**RIVER STREET PUMP STATION UPGRADE
ROCHESTER, NH**

ADDENDUM NO. 3

To be considered as part of the contract drawings and specification for the River Street Pump Station Upgrade, Bid No. 20-14.

DETAIL (M7002)

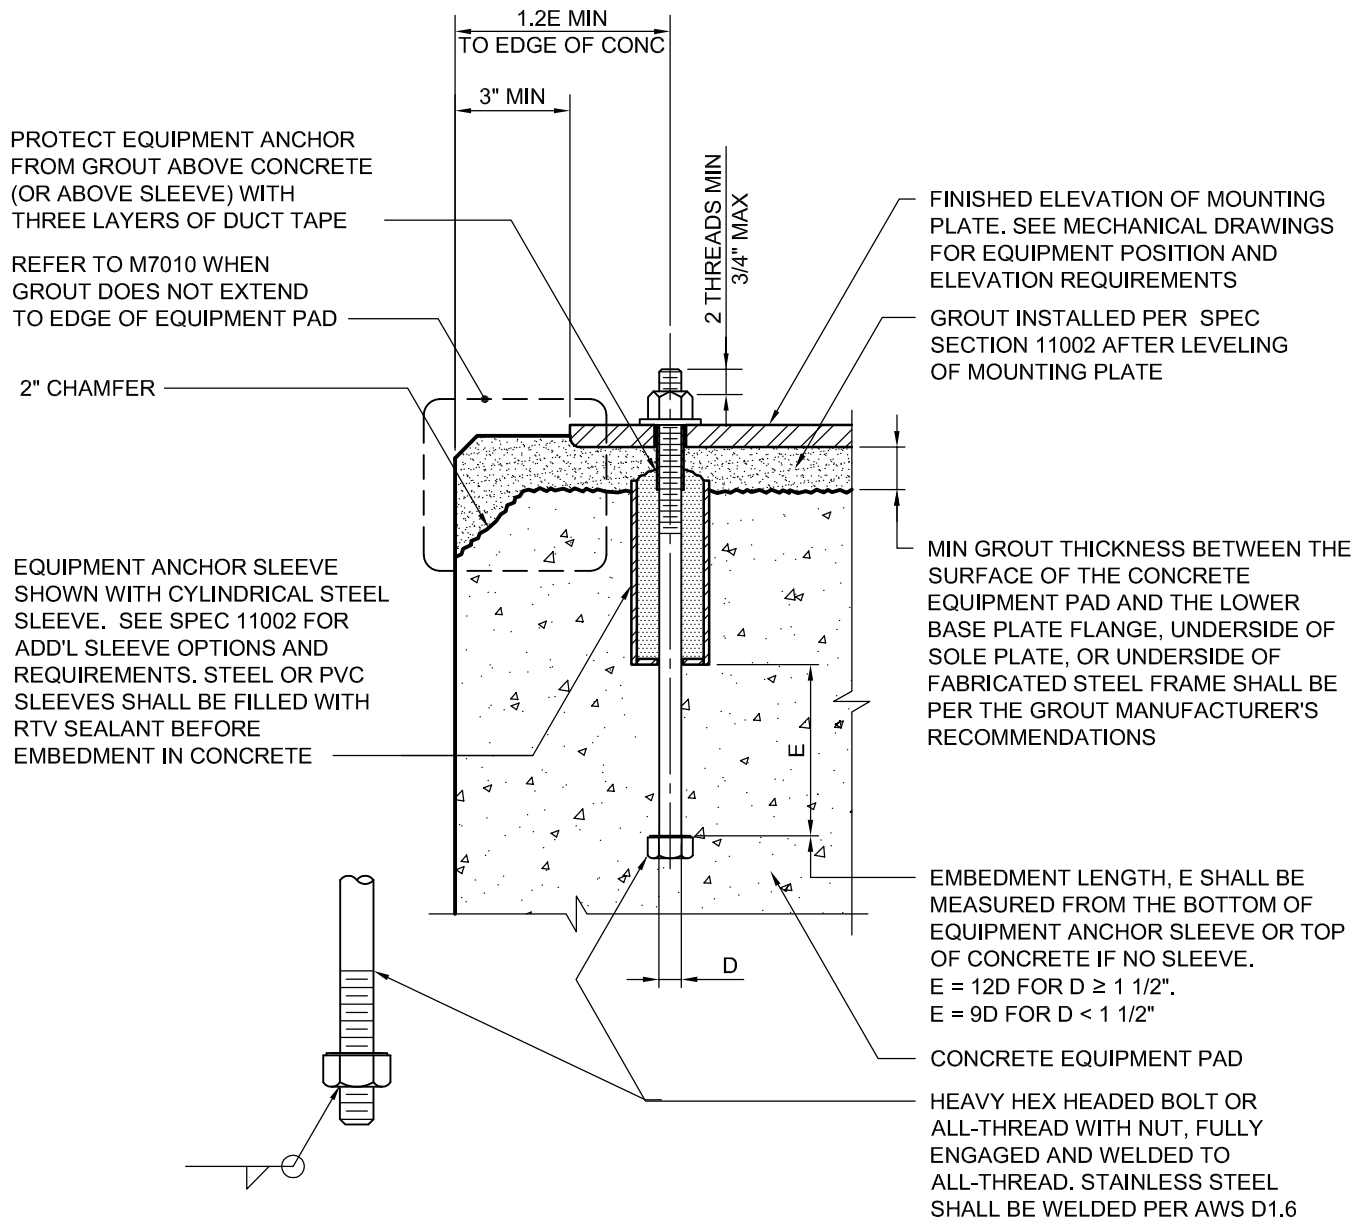
1. On Drawing D-02 **DELETE** all references to “3” SCH80 PVC DRAIN”. At the pump drains, after the stainless steel ball valve, **PROVIDE** 1-½ inch male quick connect camlock fitting and 30 feet of 1-½ inch lay flat PVC drain hose, wall thickness 0.075 inches.
2. On Drawing D-02, **ADD** reference to Detail M7002, attached.

Q-5. Spec 11344 section 2.07.C. and D. refer to standard details M7001 – M7005 and M7006 – M7008, respectively. These standard details do not appear on the process drawings. Please provide these details for the pump equipment mounts.

A-5. *Pumps shall be anchored to the house keeping pad per detail M7002, attached. The detail for the housing keeping pad can be found on S-03 detail 14.*
